Apple Valley 84

Town of Apple Valley, California

Final Environmental Impact Report

SCH No. 2025100104

Section S.0, Executive Summary

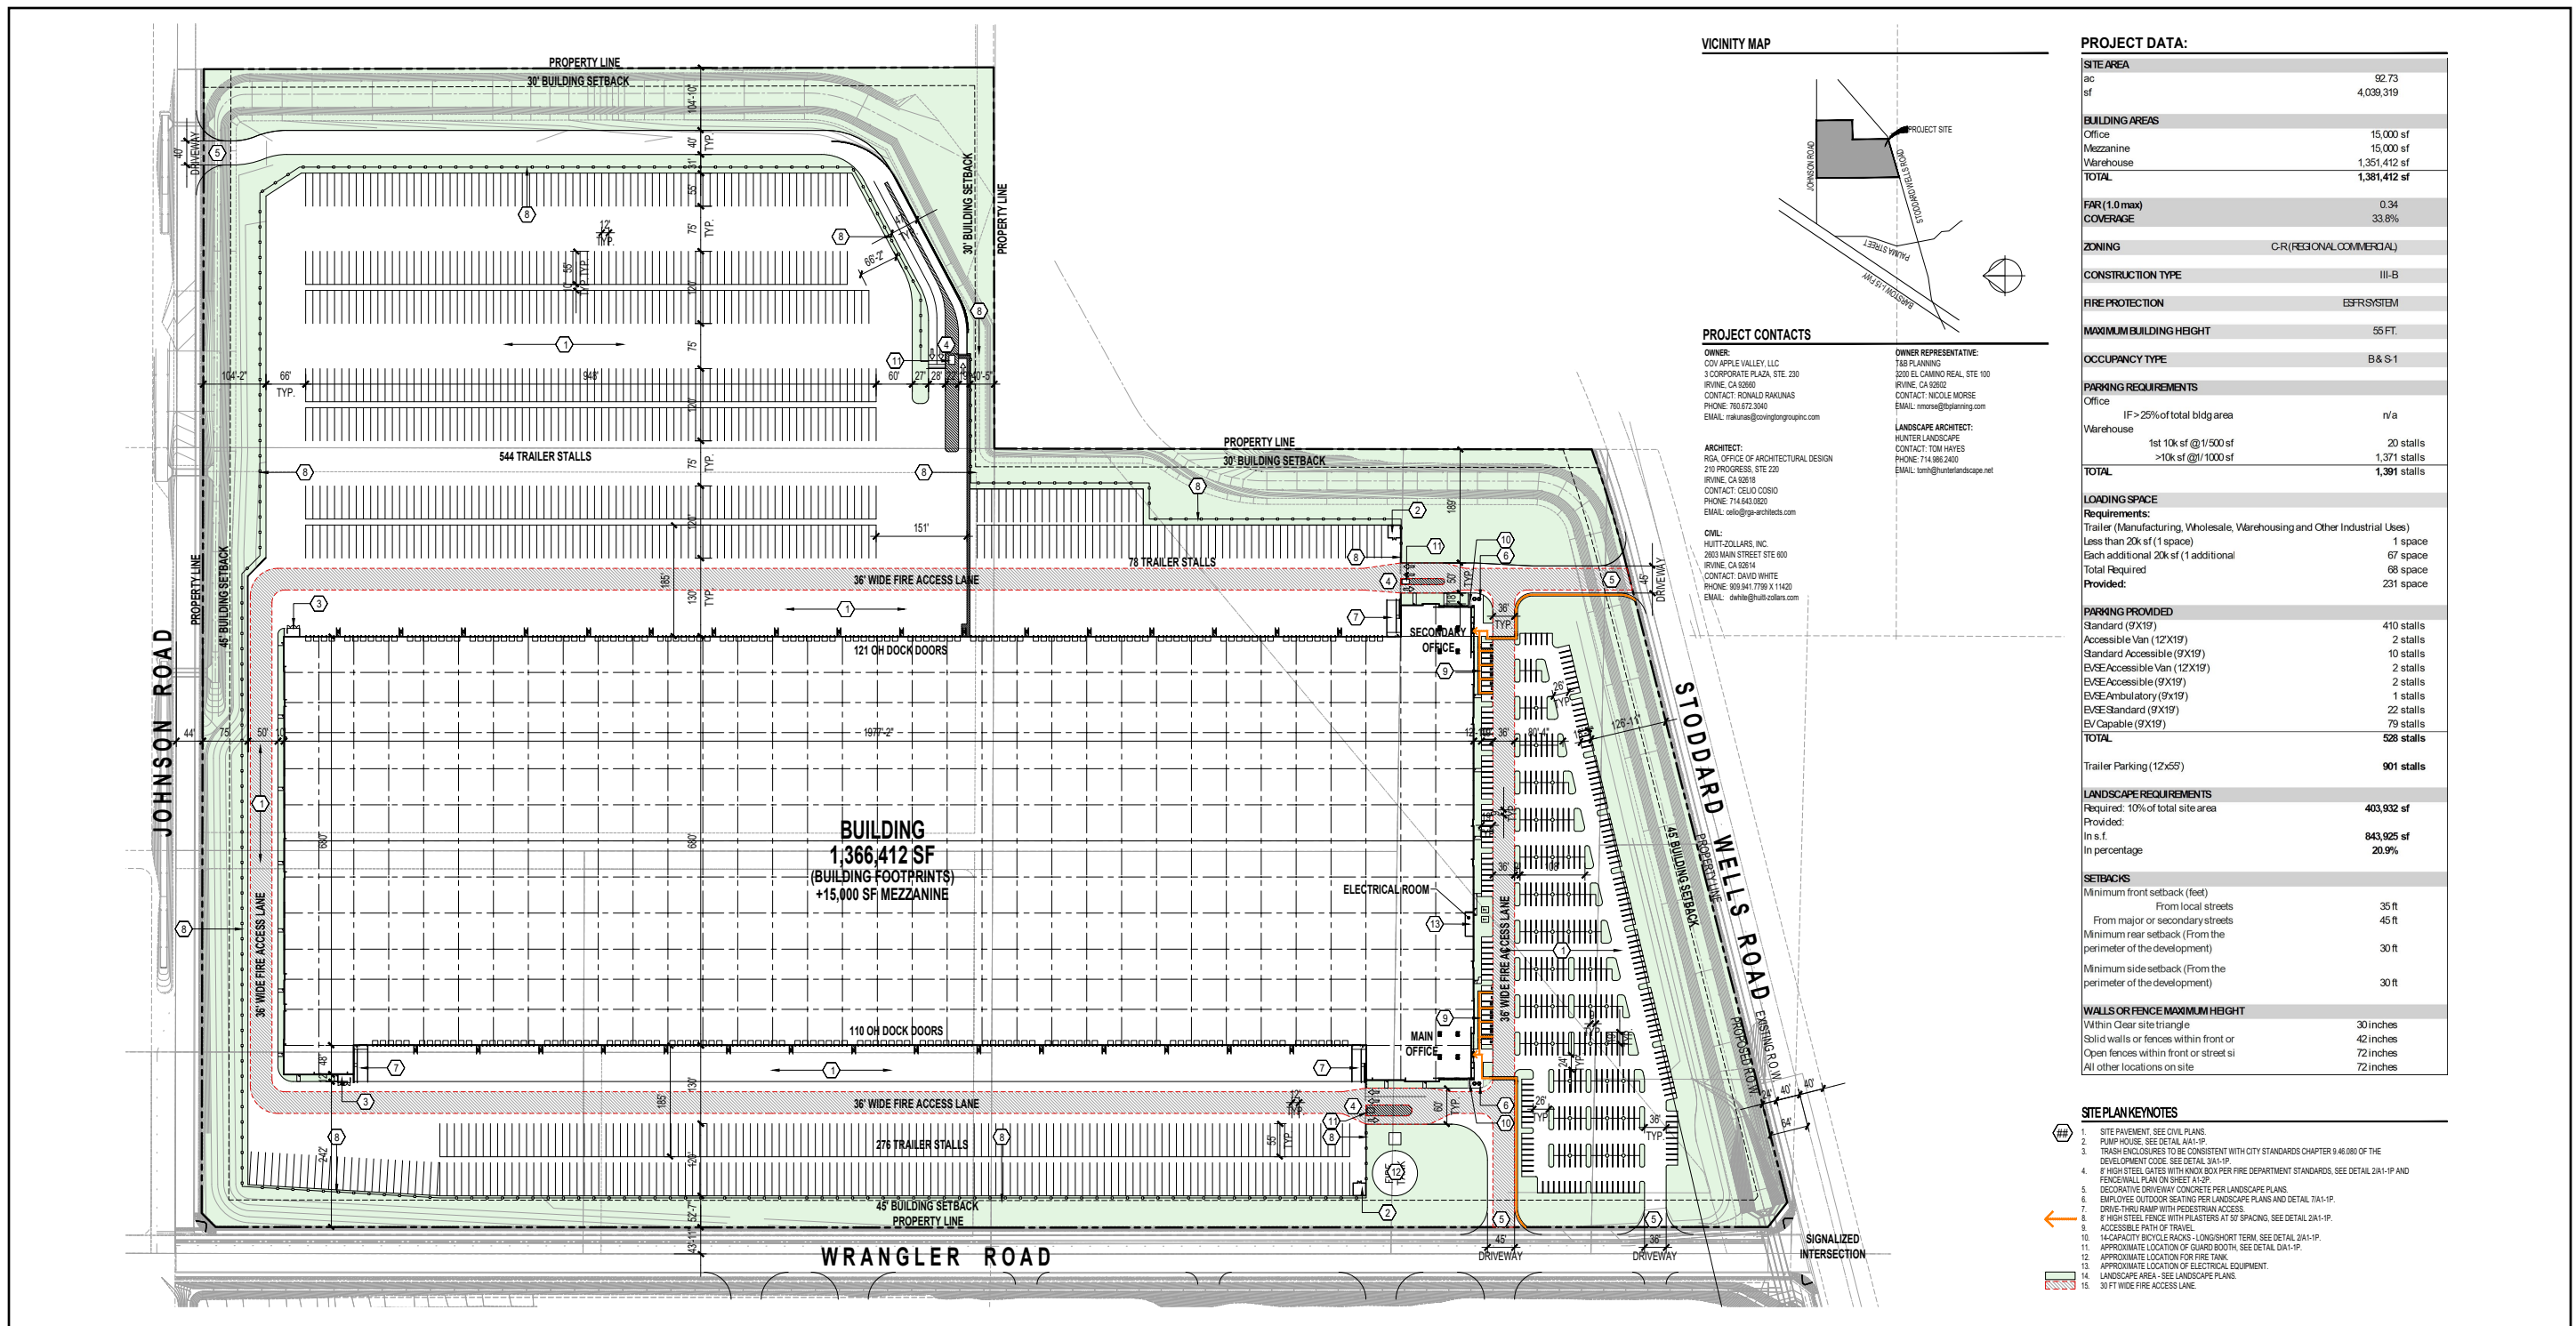
1. Pages S-1, 3-2, 3-20, and 5-6 are hereby modified due to a typographical error.

Governmental approvals requested from the Town of Apple Valley by the Project Applicant to implement the Project include General Plan Amendment (GPA) 2024-001, Zone Change (ZC) 2024-007, Development Code Amendment (DCA) 2024-001 ~~2025-003~~, Development Permit – Major Project 2025-013, Vesting Tentative Parcel Map No. 21034, and Development Agreement.
